EDWARDS STREET
85-V-3

PEAKS ISLAND

Upon examination of the cottage which you have under construction on Lot 188 Edwards Street, Peaks Island for Lavinia M. McGarry, we find the following conditions:

STATEMENT ACCOMPANYING APPLICATION FOR BUILDING PERMITS
for one family frame cottage
at Lot 188 Edwards St. Pecos Island

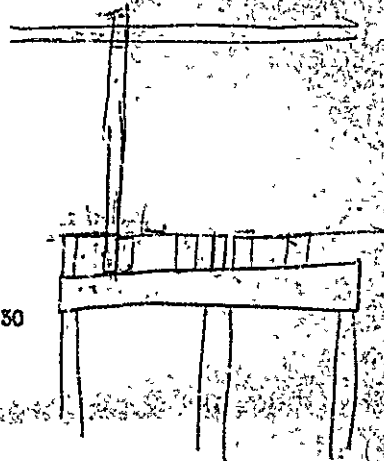
There is one splice in the sill on each side with no post under it. There is one splice in the center girder with no post under it, and another splice in the rear sill with no post to support it. The wooden posts under the girders and sill are not properly supported and braced, and there is a very poor bearing under one rear post. The carrying partition has been erected and the studs are supported right upon the floor instead of being carried down to the girder. No cap has been provided for this partition. No wall boards should have been put up in this house until after inspection and permission had been received from this office. The ceiling joists which are 2 x 6 seem to be on an unreasonably long

It is necessary for you to discontinue all work upon this cottage, and notify this office as to just how you propose to take care of these conditions that have arisen before the work is resumed.

As for the splices under the two sides and center sills, I will put a post under at once if you think best, but I was going to put cement ones under the sides this summer, as for the center wooden posts not being lashed, I have forms around them and was going to put in cement base this summer, but will lash at once, if allowed, as for the back corner post having a poor bearing, if it is the one I think you mean, it is cemented on to a large rock that can not be moved, and I am pretty sure it is safe.

As for the carrying partition, not being down to the floor sills, I admit I am all wrong there, but I nailed them to my ceiling joists and did not think to put a 2 x 4 shoe under, so if it will be allowed I will cut off from the bottom and put a 2x4 under the full length.
